AWS D1.1 Interpretation

Subject: Reentrant Corners
Code Edition: D1.1-82
Code Provision: Subsection 3.2.4
AWS Log: D1-84-016

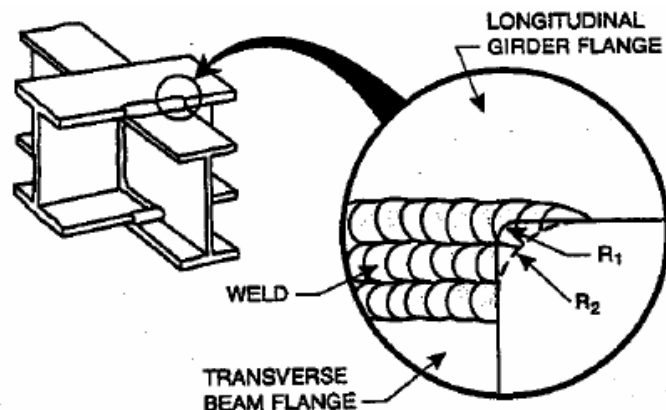
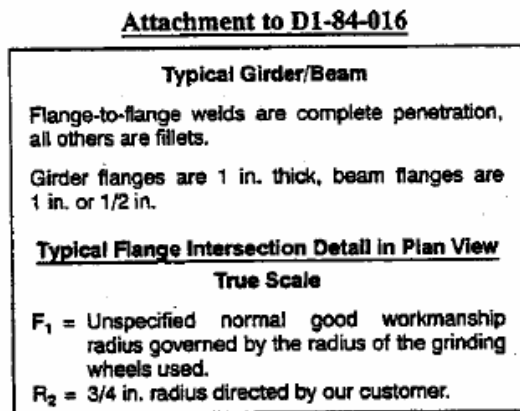
- (1) What is the definition of reentrant corners as used in 3.2.4 or AWS D1.1?
- (2) Is it readily deducible by a user of D1.1 that 3.2.4 applies in general to welded joints at intersections between members?
- (3) In the specific case illustrated in the attached sketch, does D1.1 automatically require a $\frac{3}{4}$ in. or any certain radius at intersections between the flanges, as are shown in the sketch?
- (4) If the designer requires a specified minimum radius at intersections between members, should it be detailed clearly in design drawings or specifications?

- (1) Reentrant corners are defined in *Webster's New Collegiate Dictionary* and in *Webster's Third International Dictionary*. (See also *AISC manual of Steel Construction*, 8th Edition, Page 4-167.)
- (2) No.
- (3) No. (Sketch does not illustrate a "reentrant corner.")
- (4) Yes.
